UNITED STATES PATENT AND TRADEMARK OFFICE

APPLICATION NO.	FILING DATE	FIRST NAMED INVENTOR	ATTORNEY DOCKET NO.	CONFIRMATION NO.
10/535,049	06/15/2005	Ulf Samuelsson	P/1228-200	2220
2352 7590 12/28/2006 OSTROLENK FABER GERB & SOFFEN 1180 AVENUE OF THE AMERICAS NEW YORK, NY 100368403			EXAMINER NGUYEN, XUAN LAN T	
			ART UNIT 3683	PAPER NUMBER
SHORTENED STATUTORY PERIOD OF RESPONSE		MAIL DATE	DELIVERY MODE	
3 MONTHS		12/28/2006	PAPER

Office Action Summary

DETAILED ACTION

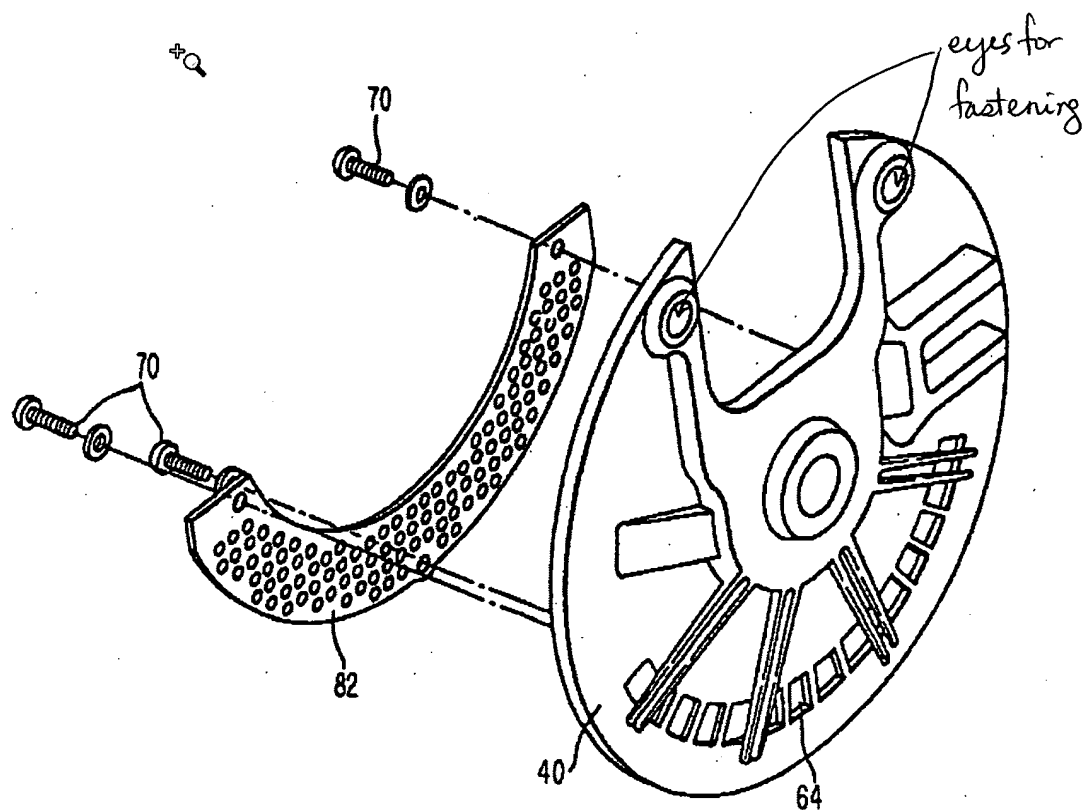
Re: claim 1, Borlinghaus shows a disc brake, as in the present invention, comprising: a disc brake including a protective shield, a wheelshaft 6, a brake disc 2, brake yoke 3 with a pair of supports 4, protective shield 8 as claimed; a protective plate 11, 15, a fastening bracket 14 to be fastened to the brake supports at 12 wherein the protective plate and the fastening bracket are separate elements which are united with each other via connecting portion 9.

Re: claim 2, figure 3 shows the protective shield to be U-shaped. Please see the drawing objection above. Applicant's drawings do not show a U-shaped cross section but shows a U-shaped protective shield 9 in figure 2. Claim 2 is being treated as claiming a U-shape protective shield.

Re: claim 3, figure 3 shows the fastening bracket portion 14 are divided into two separate fastening brackets, one on the left and one on the right.

Re: claim 10, figure 1 shows supports 4 having fastening eyes at 12.

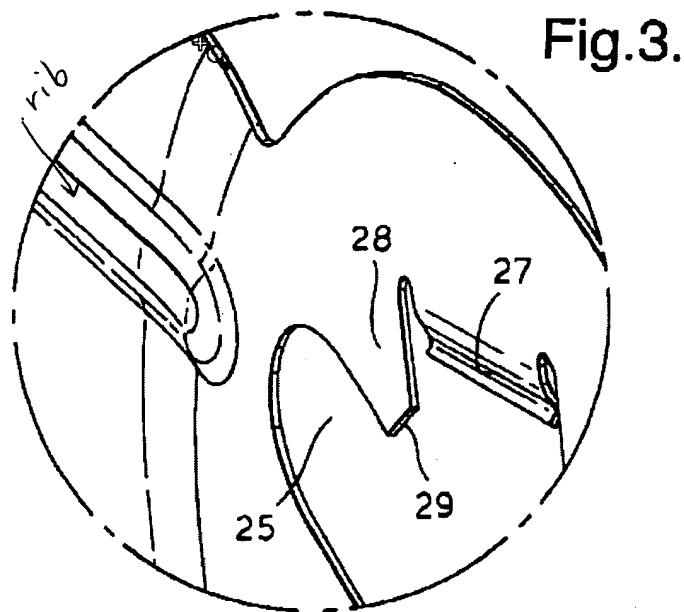
Re: claim 1, Kawaguchi shows a disc brake in figures 16-18, as in the present invention, comprising: a disc brake including a protective shield, a wheelshaft 12, a brake disc 24, brake yoke 32 with a pair of supports, protective shield 40, 82, 84 as

claimed; a protective plate 82 a fastening bracket 40 to be fastened to the brake supports as marked below, wherein the protective plate and the fastening bracket are separate elements which are united with each other via bolts 70.

Re: claim 3, figure 17 shows the fastening bracket portion 40 are divided into two separate fastening brackets, one on top and one on bottom.
